SERVICE BULLETIN

PRODUCT UPDATE: MUFFLER, HEAT SHIELD

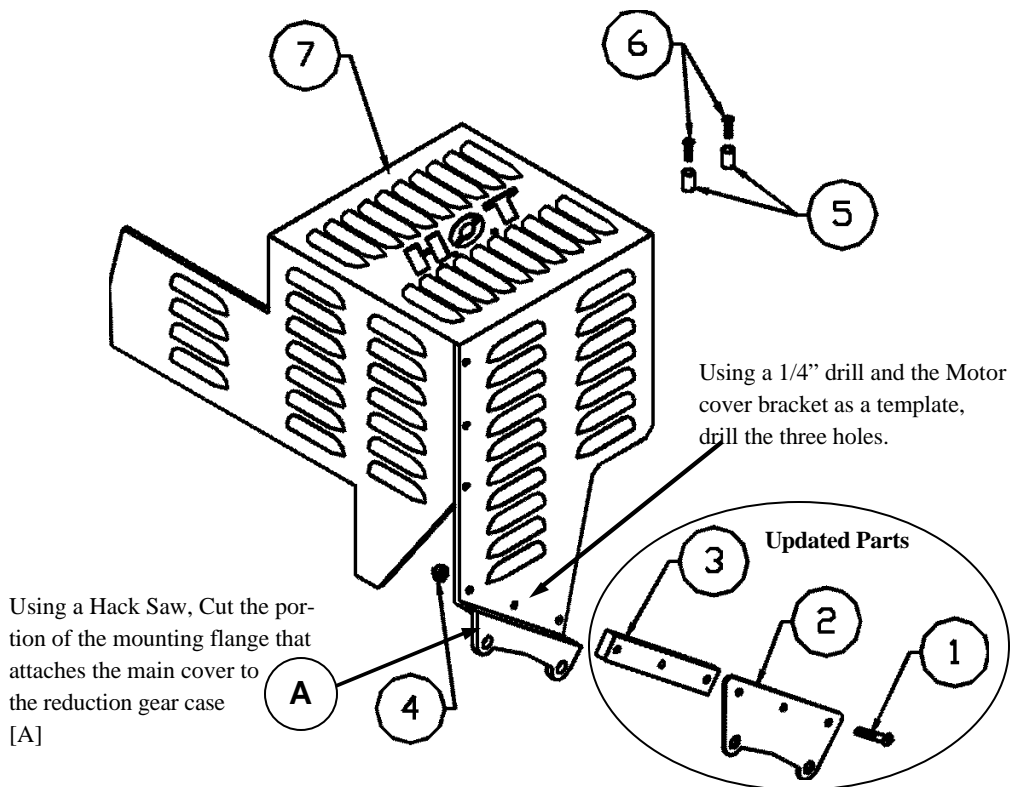
The Muffler Heat Shield breaks where it attaches to reduction gear case. (see reference [A])

Install Update immediately.

Ref#	Part#	Qty	Description
1	002961	3	Screw, 10-24 x1 Phil Pan Head SS
2	11130	1	Bracket, Motor Cover (F-16)
3	11151	1	Rubber, Anti-Vibration Motor Cover (F-16)
4	00297	3	Nut, 10-24 S/S Nylock
5	00251	2	Spacer, Honda Handle Bar
6	00115	2	Screw, 5-0.8 x 30mm P/P/H M/S Zinc
7	11112	1	Cover, Engine 9hp Silent F16
